#### MEMORANDUM

Preliminary Plan of Subdivision, Parcel 328 Four one-family detached residential lots

PROJECT NAME: Schooley Property

120060580

Attachment A Vicinity Development Map
Attachment B Proposed Development Plan
Attachment C Referenced Agency Correspondence

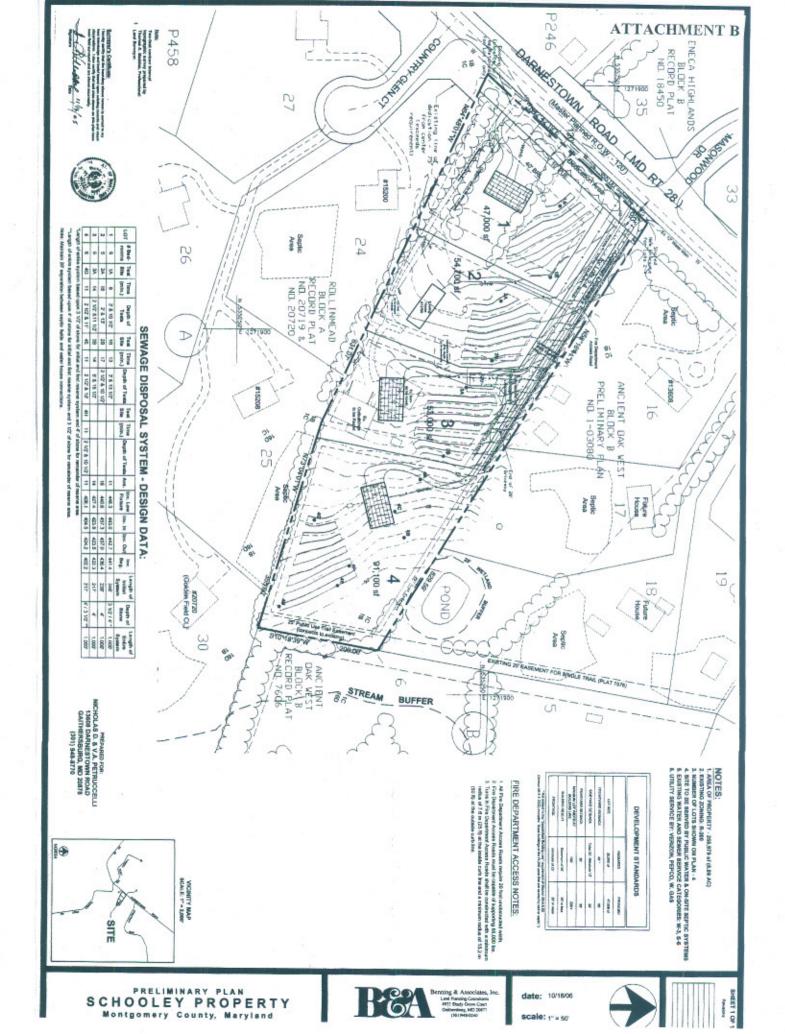
We have completed our review of the preliminary plan dated 11/16/06. This plan was reviewed by the Development Review Committee at its meeting on 12/19/05. We recommend approval of the plan subject to the following comments:

- Show all existing planimetric and topographic details specifically paving, storm drainage, driveways adjacent and opposite the site and sidewalks.
- 2. Necessary dedication for Darnestown Road (MD 28) in accordance with the master plan.

- Grant necessary slope and drainage easements. Slope easements are to be determined by study or set at the building restriction line.
- Wells and septic systems cannot be located within the right of way nor slope or drainage easements.

- 5. We did not receive complete analyses of the capacity of the downstream public storm system(s) and the impact of the post-development runoff on the system(s). As a result, we are unable to offer comments on the need for possible improvements to the system(s) by this applicant.
  Prior to approval of the record plat by the Department of Permitting Services (DPS), the applicant's consultant will need to submit this study, with computations, for review and approval by DPS. Analyze the capacity of the existing downstream public storm drain system and the impact of the post-development ten (10) year storm runoff on same. If the proposed subdivision drains to an existing closed section street, include spread and inlet efficiency computations in the impact analysis.

- Record plat to reflect a reciprocal ingress, egress, and public utilities easement to serve the lots accessed by each common driveway.

- Private common driveways and private streets shall be determined through the subdivision process as part of the Planning Board's approval of a preliminary plan. The composition, typical section, horizontal alignment, profile, and drainage characteristics of private common driveways and private streets, beyond the public right-of-way, shall be approved by the Planning Board during their review of the preliminary plan.

- Revise the plan as necessary to meet the requirements of the Montgomery County Department of Permitting Services with regard to wells and/or septic systems.

- Access and improvements along Darnestown Road (MD 28) as required by the Maryland State Highway Administration.
- Please coordinate with DPWT division of Transit Services about their requirements and project impacts on their network.
